Title of Change:	NCV78343 datasheet update
Effective date:	06 Jun 2023
Contact information:	Contact your local onsemi Sales Office or Dalibor.Bartos@onsemi.com
Type of notification:	This Product Bulletin is for notification purposes only. onsemi will proceed with implementation of this change upon publication of this Product Bulletin.
Change Category:	Datasheet update
Change Sub-Category(s):	Datasheet/Product Doc change

Datasheet update from NCV78343/D Rev. 2 to NCV78343/D Rev. 3

Figure 16. PXN Frame

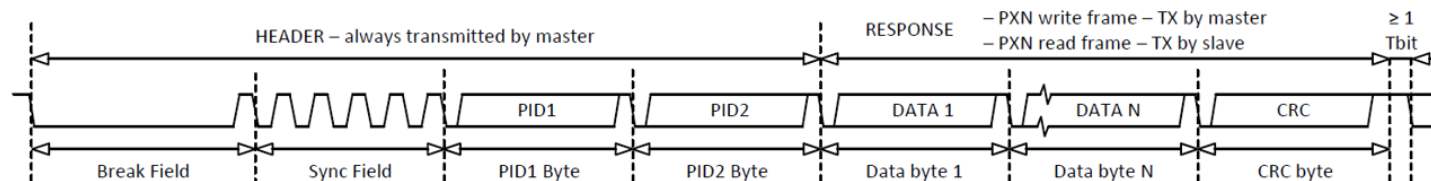
Page 17 – Figure changed to improve clarity
